Re: Proposed County Road Underpass,  
Hwy. 401, Twps. Southwold & Delaware,  
W.P. 64-59 -- District No. 2

REVIEW OF DRAWING by  
Foundation Section.

We have reviewed the proposed general arrangement for the bridge No. 2, Delaware Township, submitted by De Leuw, Cather & Company of Canada, Limited, Consulting Engineers.

CORRECTION TO FOUNDATION REPORT

Sketch showing correct position  
of borings WP 64-59 HWY 401  
underpass.

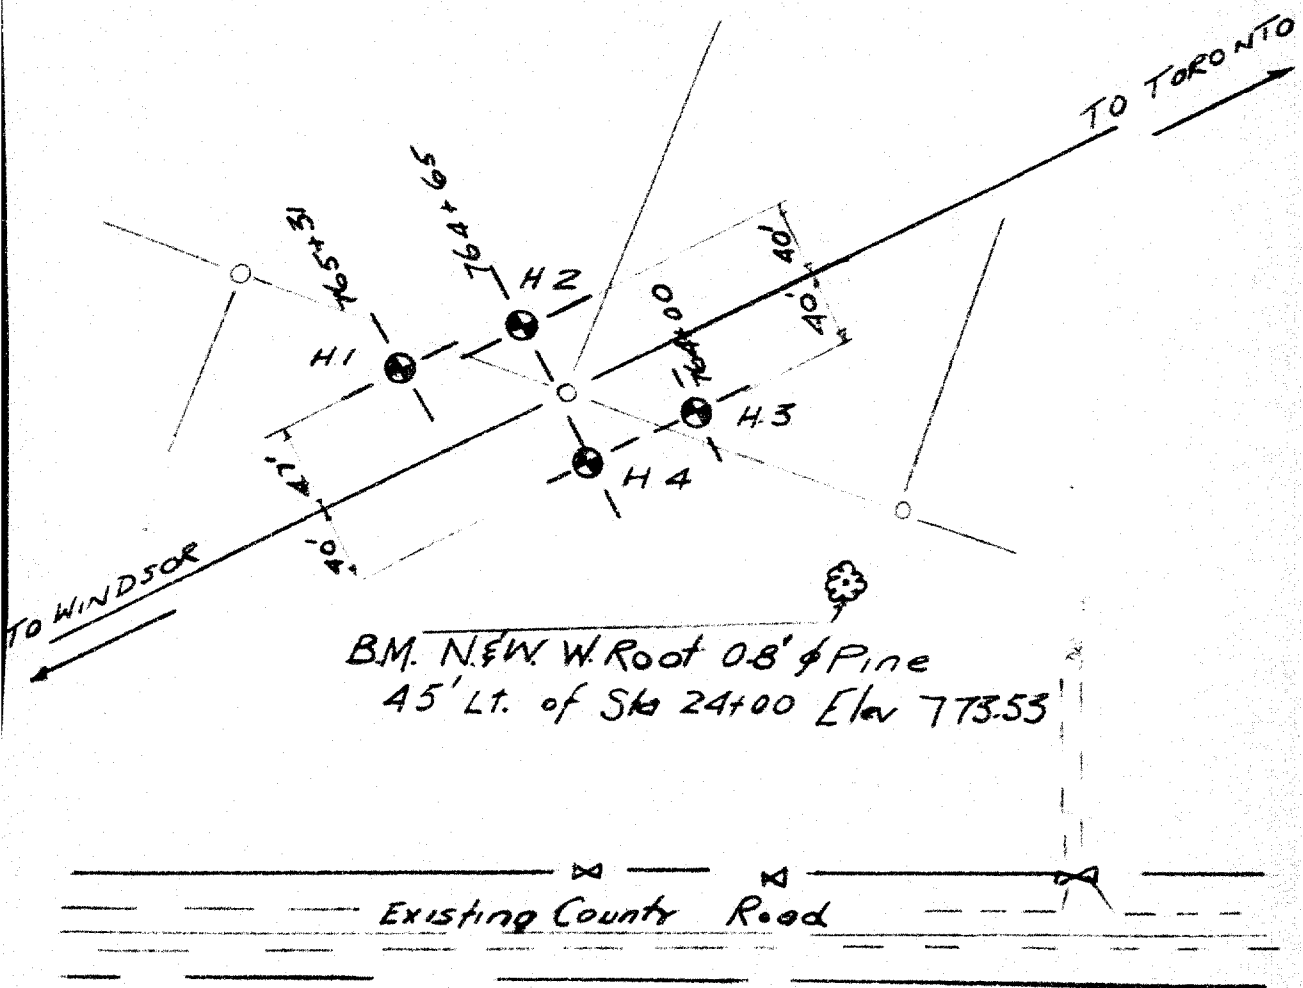
We have learned that our borehole location plan for the above project shows one borehole plotted in the wrong position. This drawing forms part of our report of May 13, 1960 for the Hwy. 401 Underpass, Southwold Township.

The station locations were referred to correctly but the plotted position of one hole was incorrect. In error we have also interchanged the locations of holes 2 and 4. The attached sketch, which is an overlay of part of this borehole plan, shows the correct locations of the holes.

Sketch showing correct position  
of borings WP 64-59 HWY 401  
underpass.

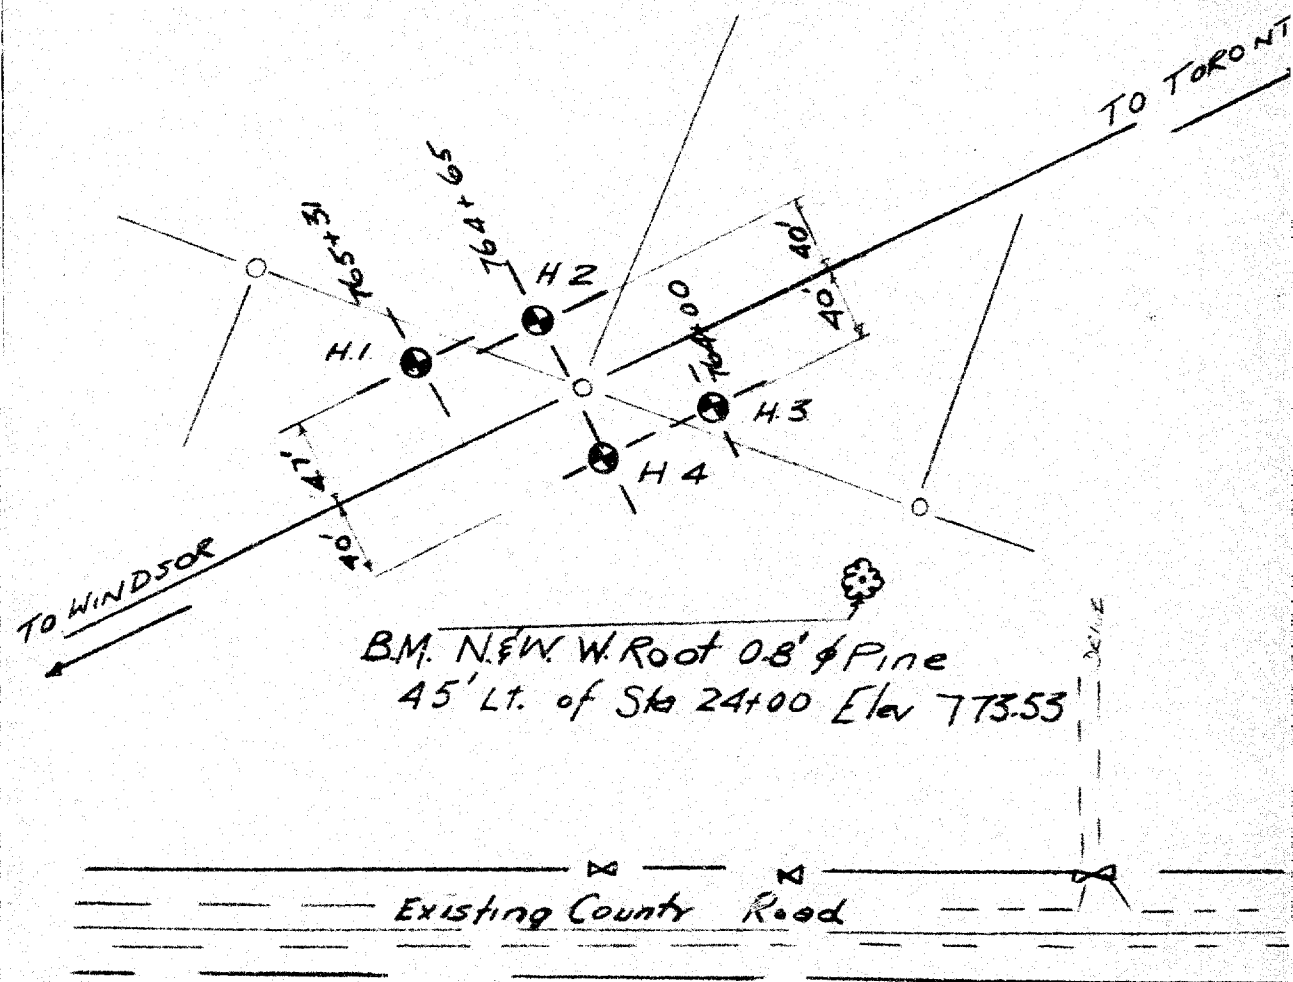
We have learned that our borehole location plan for the above project shows one borehole plotted in the wrong position. This drawing forms part of our report of May 13, 1960 for the Hwy. 401 Underpass, Southwold Township.

The station locations were referred to correctly but the plotted position of one hole was incorrect. In error we have also interchanged the locations of holes 2 and 4. The attached sketch, which is an overlay of part of this borehole plan, shows the correct locations of the holes.

Sketch showing correct position  
of borings WP 64-59 HWY 401  
underpass.

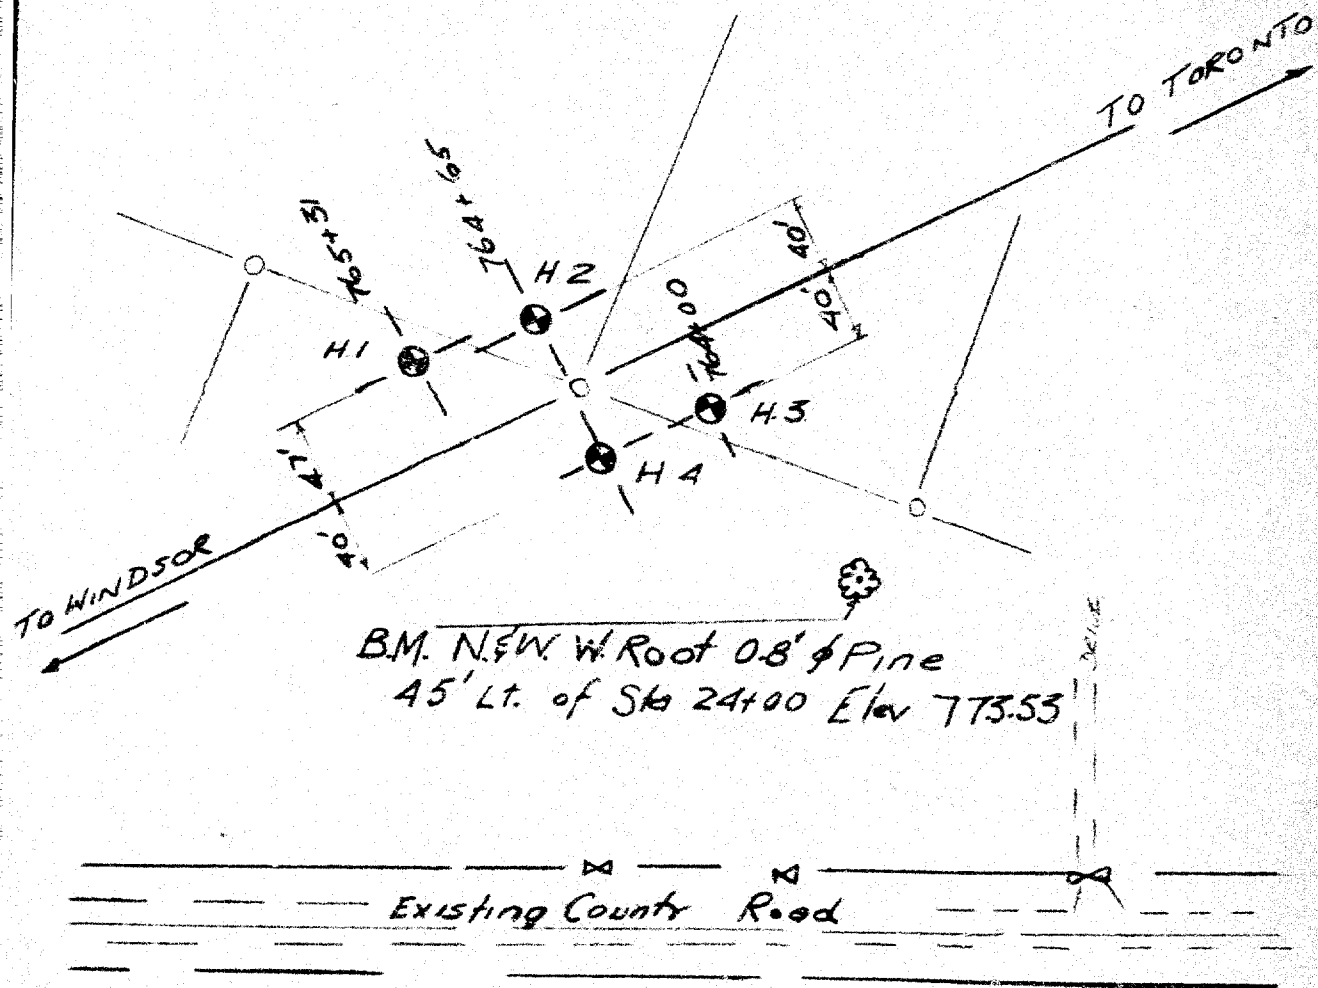
We have learned that our borehole location plan for the above project shows one borehole plotted in the wrong position. This drawing forms part of our report of May 13, 1960 for the Hwy. 401 Underpass, Southwold Township.

The station locations were referred to correctly but the plotted position of one hole was incorrect. In error we have also interchanged the locations of holes 2 and 4. The attached sketch, which is an overlay of part of this borehole plan, shows the correct locations of the holes.

D-4686-P

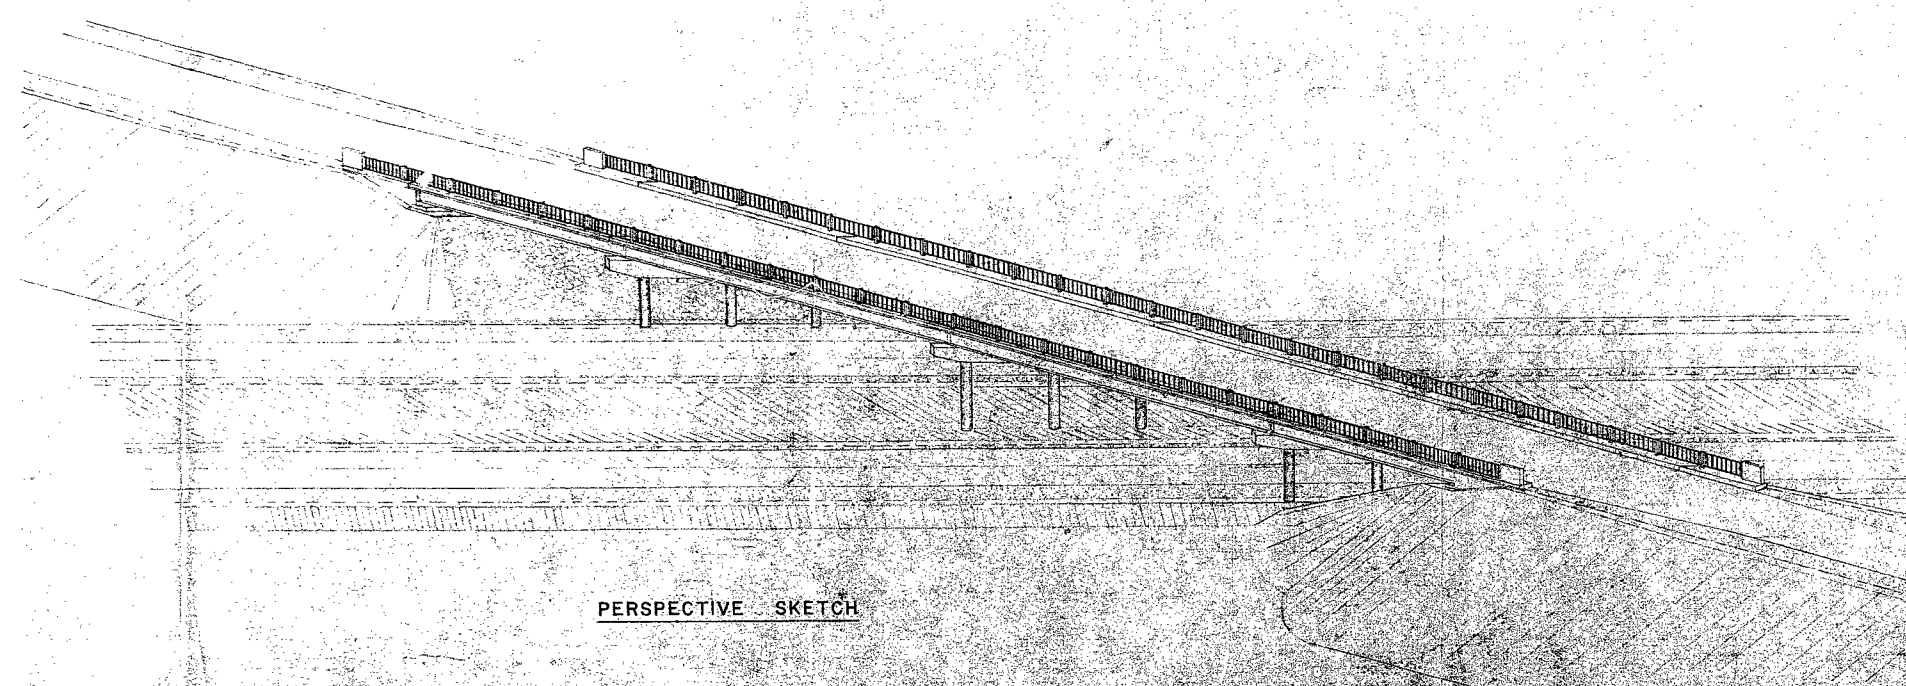
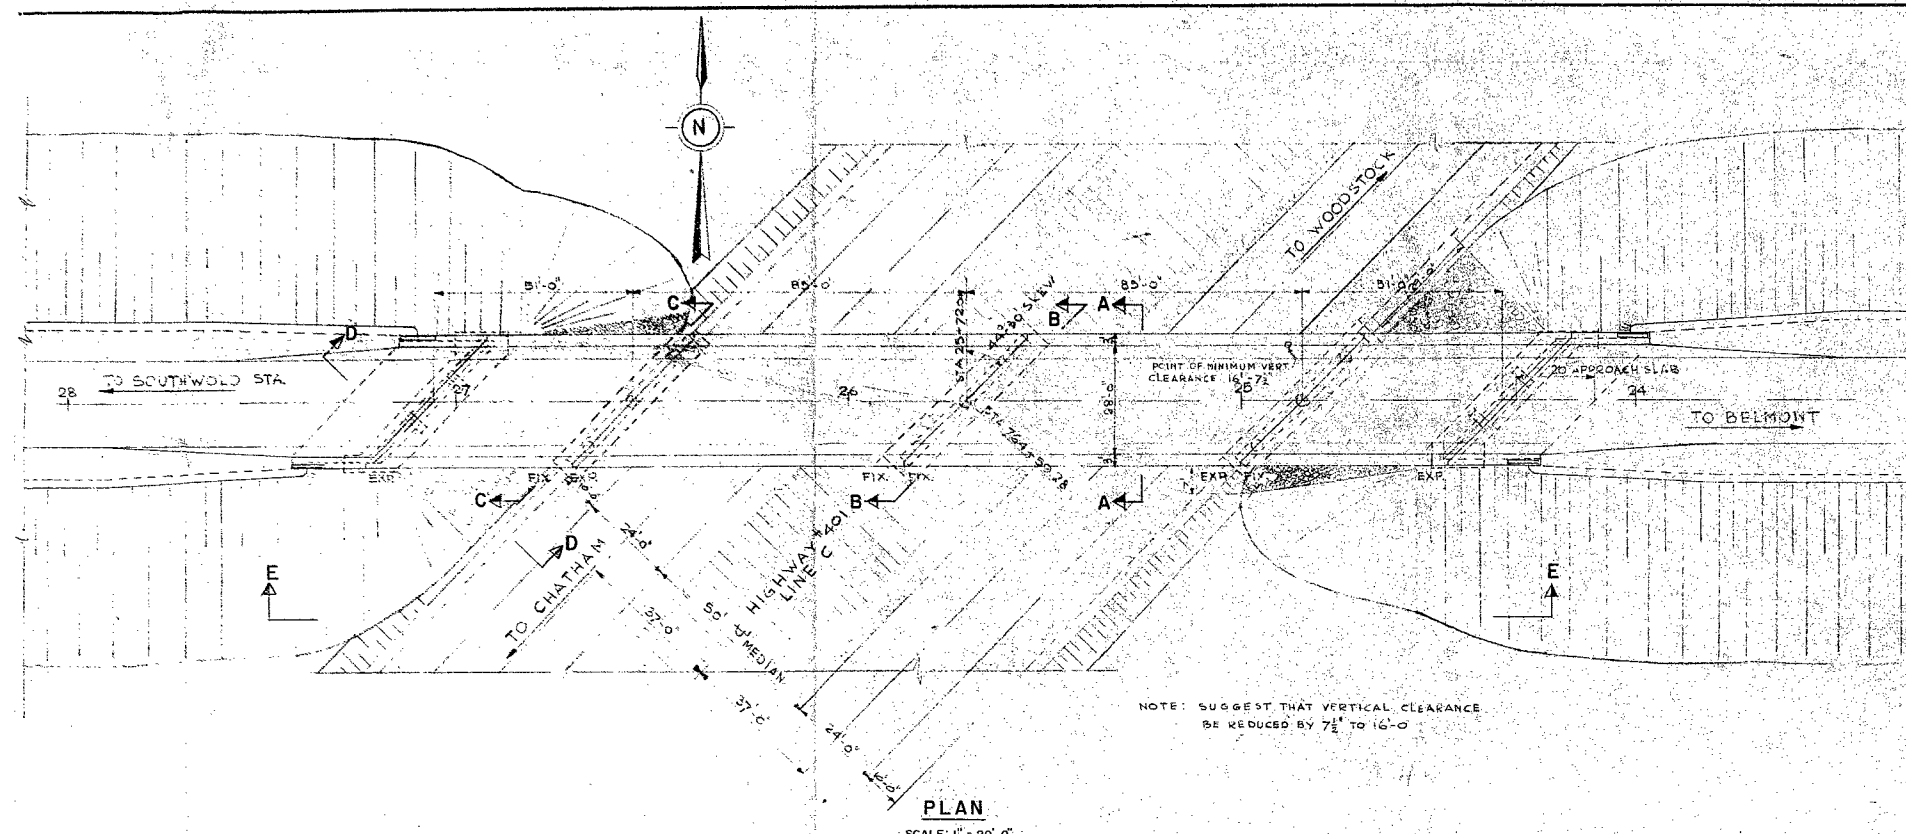
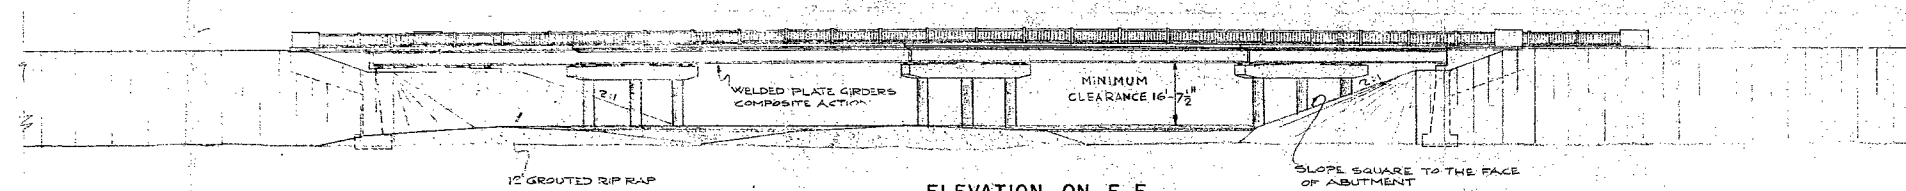
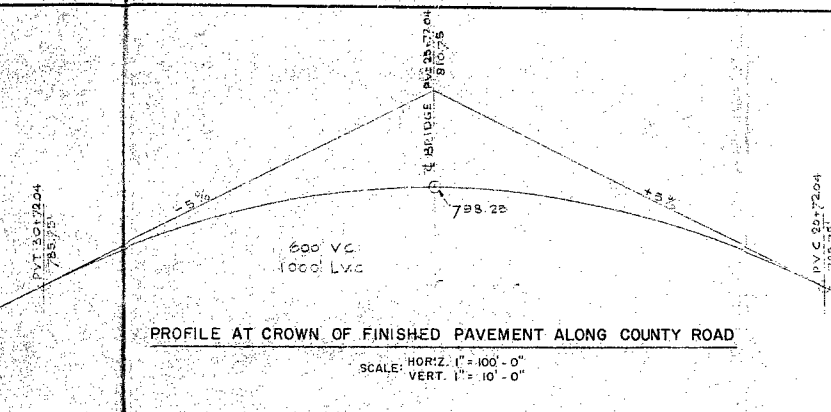
The recommendations for the foundation of the structure have been followed except in the case of the abutment footings. These footings are placed directly on the existing ground surface, as shown on Drawing No. D-4686-P. In the Foundation Report it is stated that the upper 2 1/2 feet of the ground are top soil with root hairs. Such a material is not suitable as a foundation support and should, therefore, be excavated and the footings placed at a lower level.
